Our Ref: 9483

Re: Proposed New Development at 27-29 North Avalon Road, Avalon Beach – Assessment of Distance and Path of Travel to the Bus Stops – State Environmental Planning Policy (Housing for Seniors or People with a Disability) 2004.

The kerb ramp provided on the corner of North Avalon Road and Catalina Crescent.

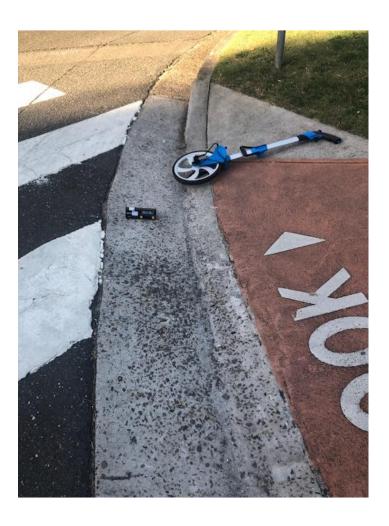
2. The kerb ramp provided on the corner of North Avalon Road and Catalina Crescent (south side of North Avalon Road at the pedestrian crossing) has a gradient that is steeper than 1:8. This is not compliant with the maximum gradient of 1:8 allowed under clause 26 (3)(iii). See photo below. The sections steeper than 1:8 is the orange section in the photo below as well as the grey section. The orange section gradient was approximately 1:5.8 and the grey section was approximately 1:6.5.

We note that this is the kerb ramp that leads directly to the pedestrian crossing and is deemed the shortest and safest route to gain access to the bus stops. This kerb ramp and kerb section will need to be reconstructed to achieve a gradient not steeper than 1:8 to comply with the SEPP.
